**CARDINAL FREEMAN VILLAGE
137 Victoria Street, Ashfield**

**S75W APPLICATION TO MODIFY
CONCEPT PLAN APPROVAL MP 08_0245
AND
PROJECT APPROVAL MP08_0260**

RESPONSE TO SUBMISSIONS REPORT

**Prepared for
Stockland Property Services Pty Ltd**

Relationship of Building 4 to Chapel

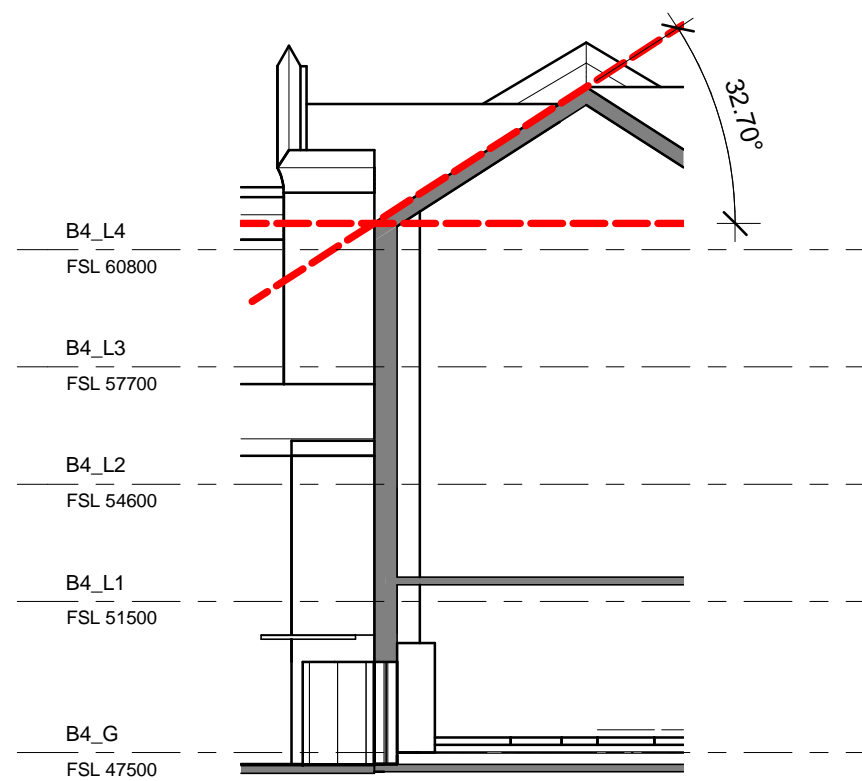
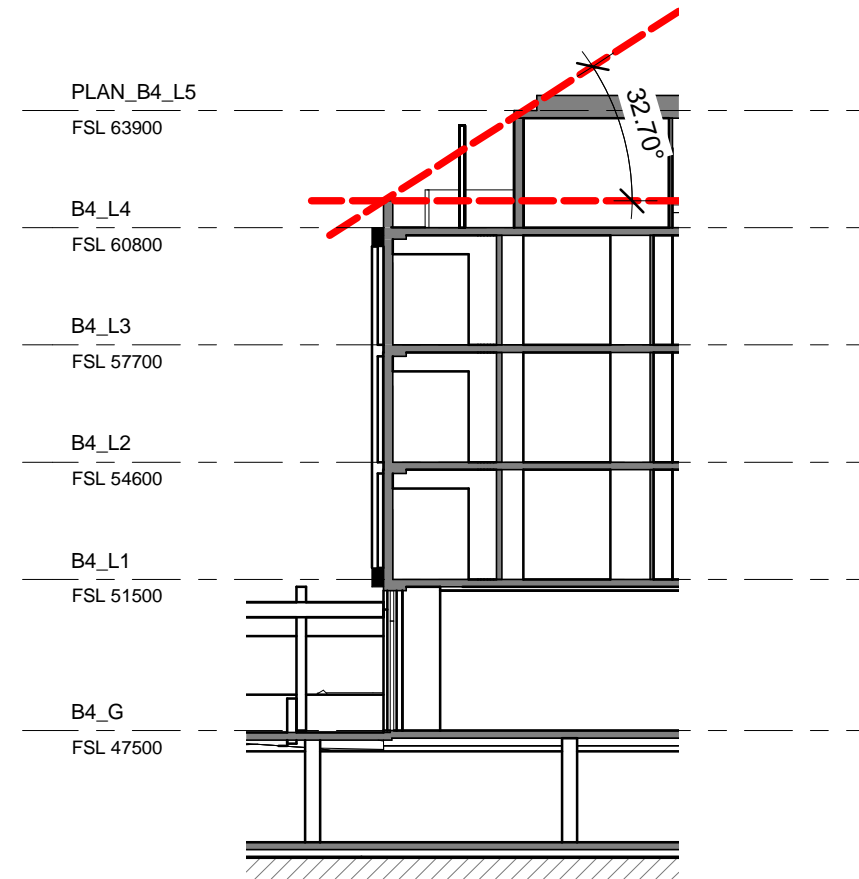
Additional consideration of the impacts of the increased height of Building 4 above the eaves line of the Glentworth House and Chapel, in particular, the following issues should be addressed:

Assessment of this aspect of the modification and its impact on the heritage item (it is noted that this was not dealt with within the Heritage impact Statement prepared by Graham Brooks and Associates);

Comparison section/elevation plans showing the relationship between Building 4 and the heritage item (approved and proposed) should be provided.

The diagrams contained in Appendix 1 provide more details of the relationship between the Chapel and Building 4. Building 4 is higher than the approved Concept Plan (RL64.3m compared to RL61.6m). However the parapet height of this building is below the eaves height of the Chapel (RL61.6m) with the upper level setback and the overall height of the building at RL64.3m) being lower than the ridge height of the chapel (RL65.10m). This achieves the design intent of allowing the roof elements of the Chapel and Glentworth House to be dominant in height on the site when viewed from the public domain. Building 4 is located towards the centre of the site and will appear recessive when viewed from the surrounding streets and the re-established heritage garden setting.

Drawing DA2101 Issue H

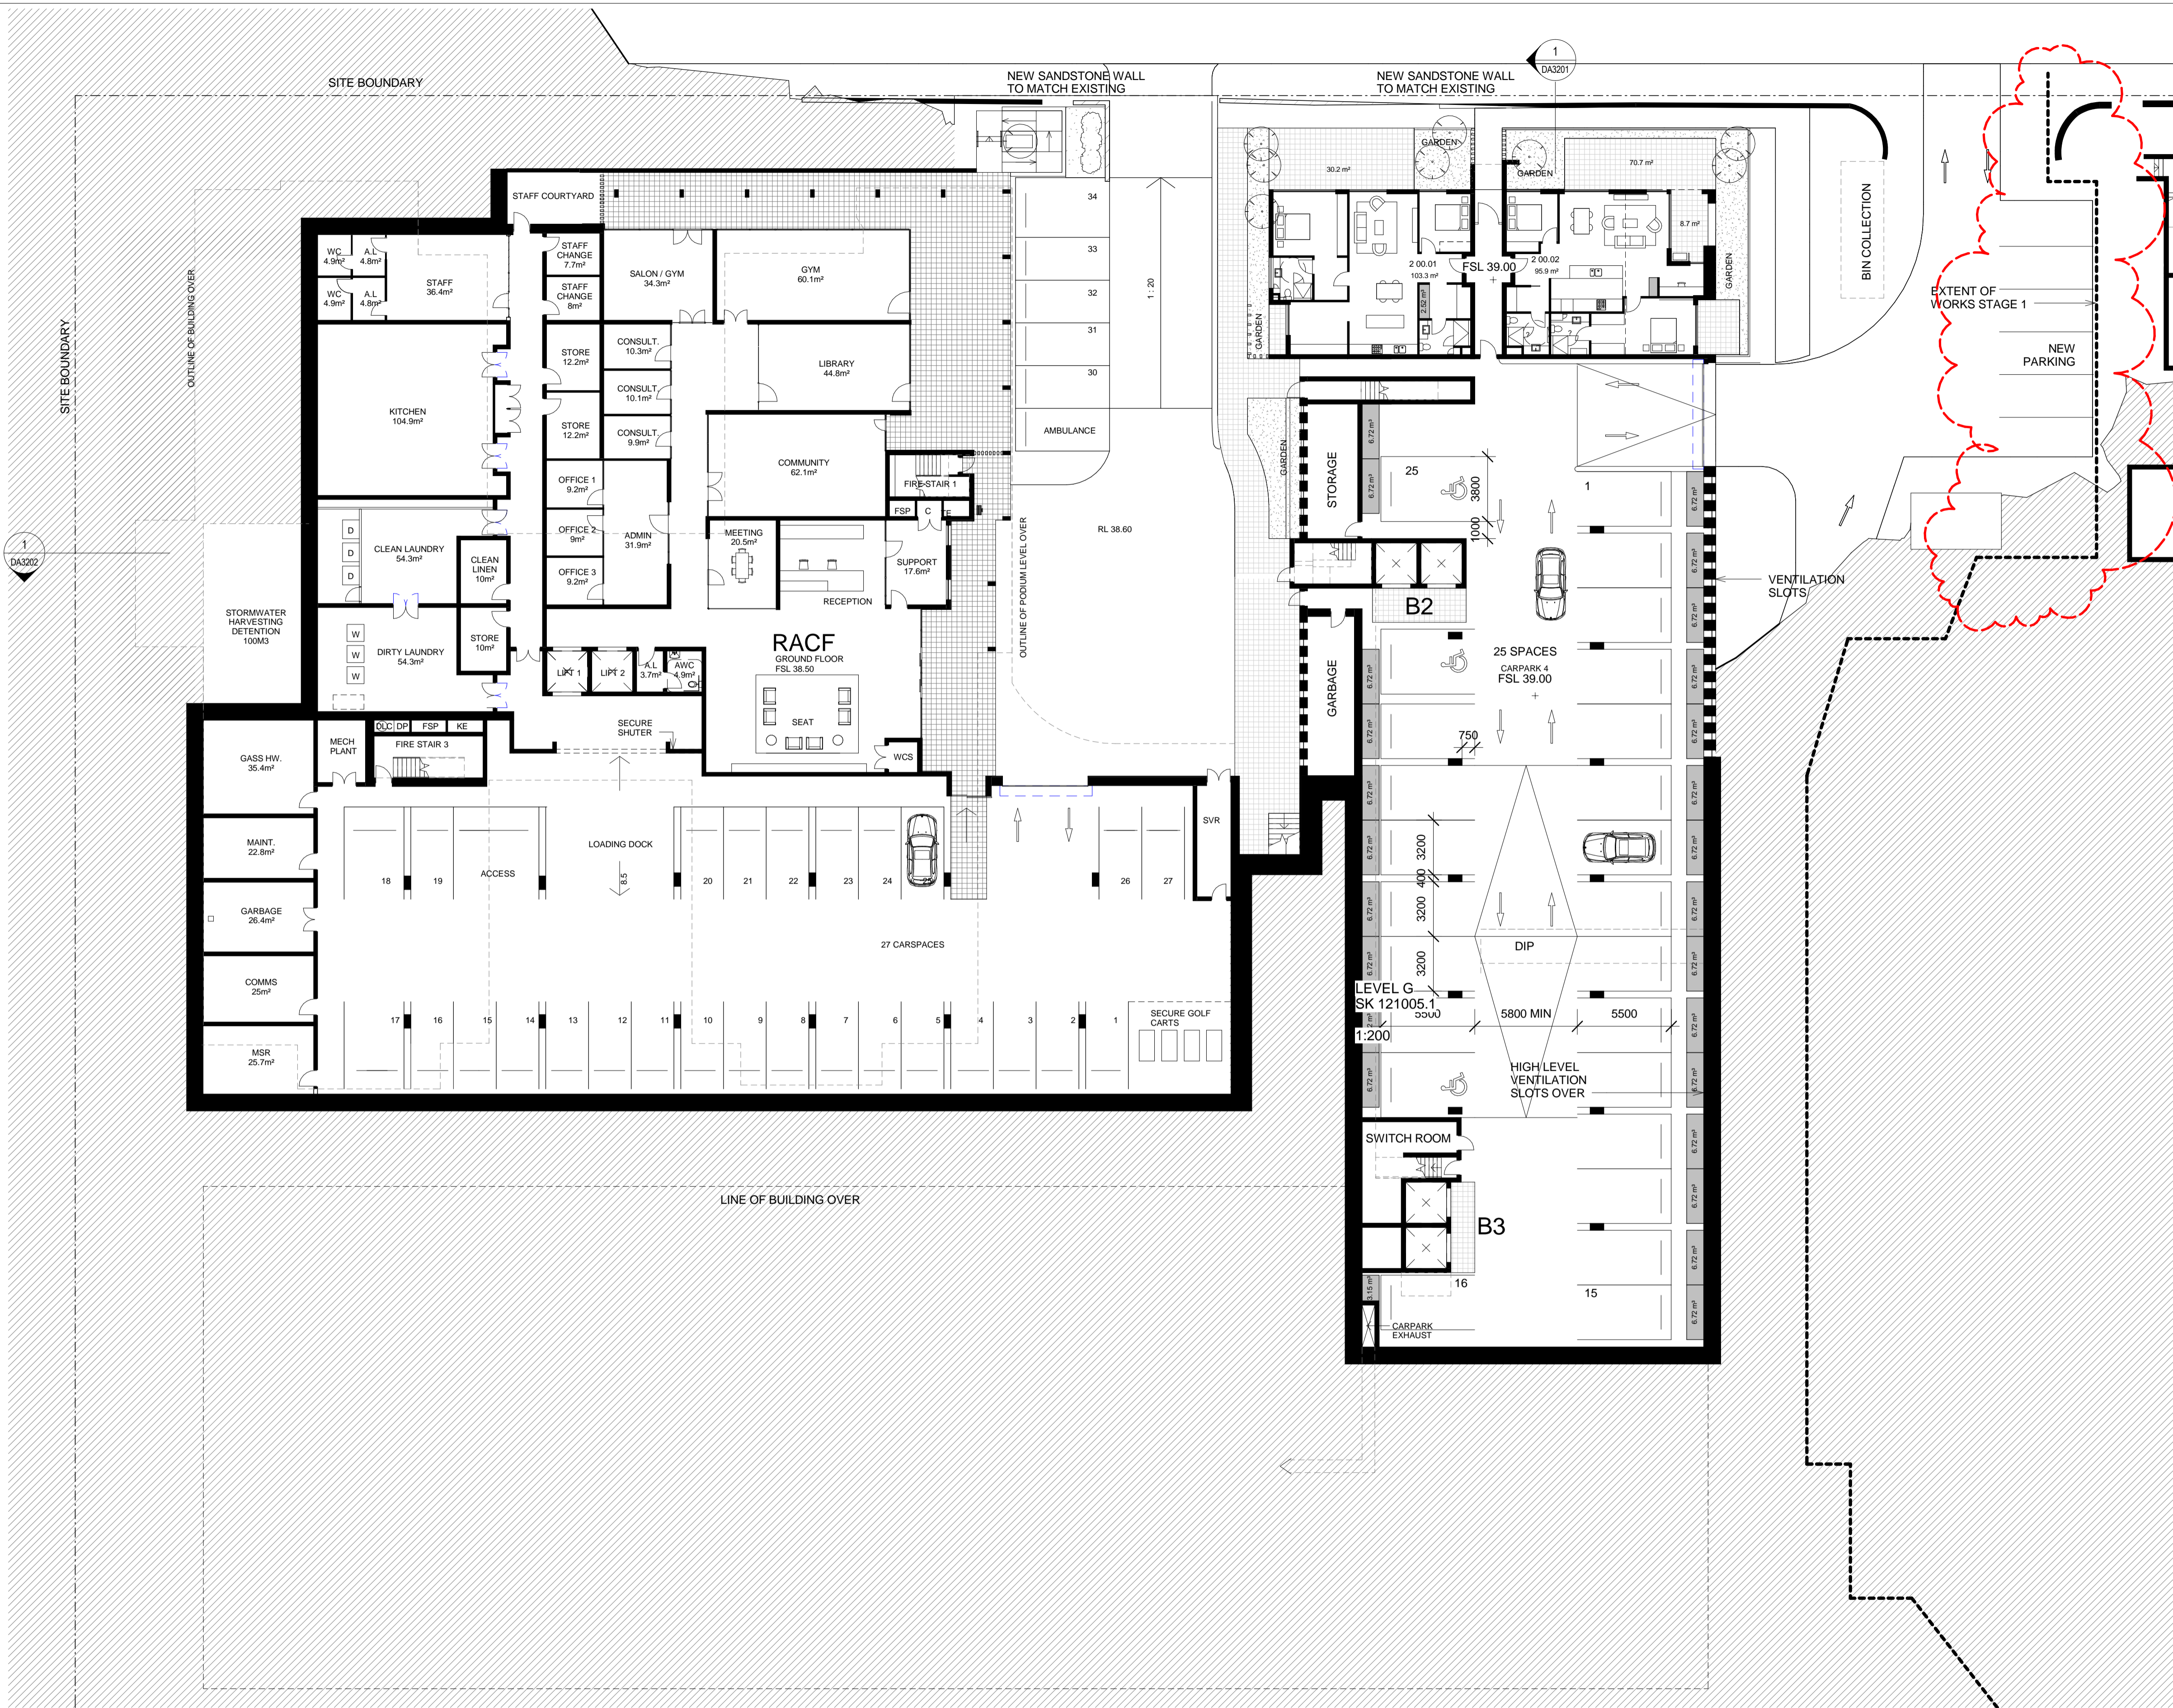
Clarification on the boundaries of construction stages (Stage 1 and Stage 2) for the Project Application. Drawing No. DA1002 shows the proposed car parking spaces to the east of Building 2 as fully within the stage boundary, however Drawing No. DA2101 shows the parking spaces outside of Stage 1. It is not clear whether these spaces will be provided as part of Stage 2 construction works or a future stage.

Drawing DA2101 has been amended to show the correct staging boundary. This drawing (Issue H) is contained in Appendix 4.
